Company: Hinckley and Bosworth Borough Council

Project No. 410.066282.00001

**RE: 25/00931/FUL Cliffe Hill Farm, Little Shaw Lane, Markfield LE67 9PP
Consultee Commentary Response – Noise**

Figure A: Specific Sound Levels, Highest dB LAeq,T at Building Façades – Daytime

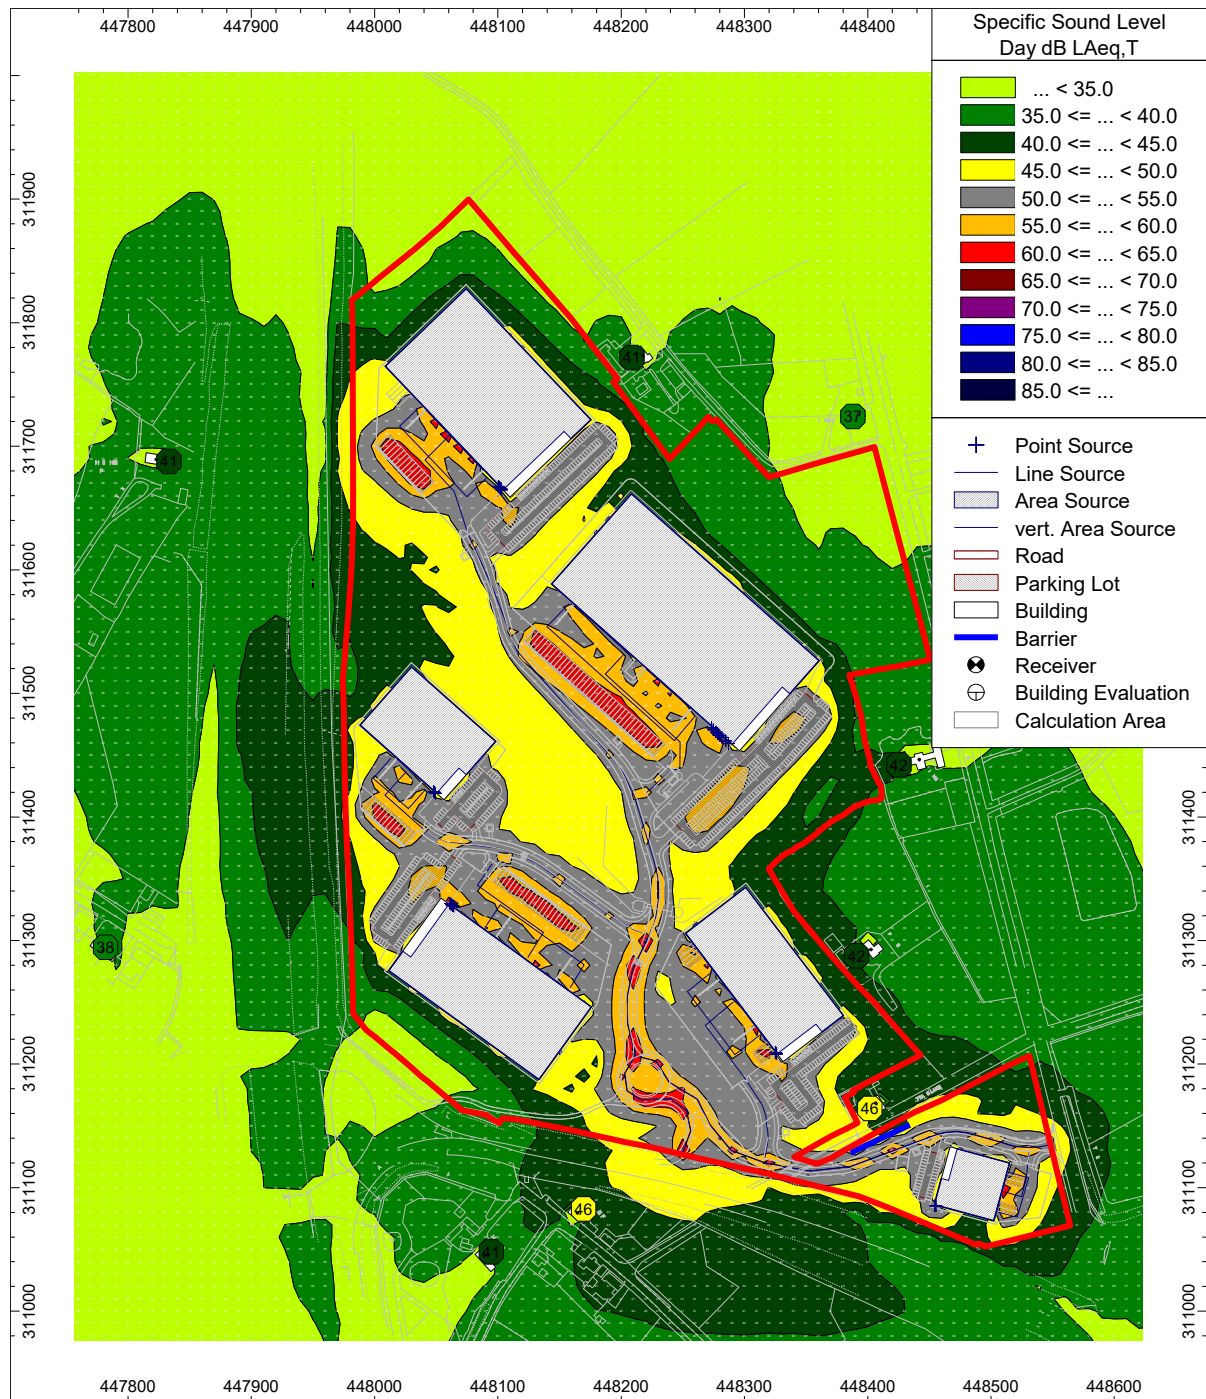
“The noise contours from the model should be submitted.”

“Consideration is required on the impact from noise on external amenity areas of the adjacent residential premises.”

Further noise modelling outputs have been developed further to consultee comments. Please see Figure A, Figure B and Figure C of this memorandum. Note these contours have been drawn using a 10 m x 10 m grid, above a relative (future) ground height within the Site and existing contours outside of the Site. The predicted noise levels remain significantly below an acceptable level at all sensitive receptors.

Modelling contours have been recalculated at 1.5 m height alongside the façade predictions as previously reported. It shall be observed that the consideration of noise in external amenity areas, at 1.5 m above relative ground level, typically poses lower sound levels than assessed at first building façades. Consequently, when considering the noise impact on external amenity areas of the adjacent residential premises, the updated noise modelling shows no adverse impacts given sound levels appreciably below the submitted assessment.
